| MATL. & SPEC. | FOR ASSEMBLY | |
|---|----------------------------|--|
| THERMOPLASTIC POLY URETHANE MOULDED INSULATION RDSO/SPN/S/168/02 | COLLAR BUSH - LARGE | |
| | DRG.No.: CWM 05722 | |
| | ALT.No.: 1 | |
| S & T WORKSHOP, S.RLY, PODANUR. | | |

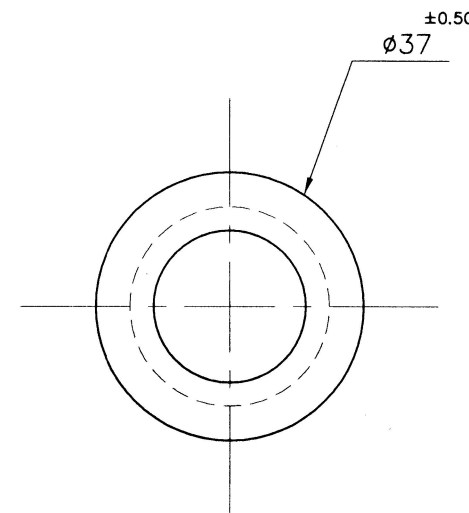
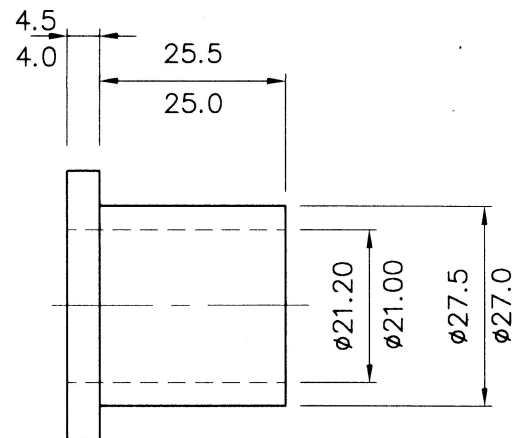
1. DIA DECREASED FROM 40mm TO 37
2. THICKNESS OF COLLAR INCREASED FROM 3.5/3.0 TO 4.5/4.0
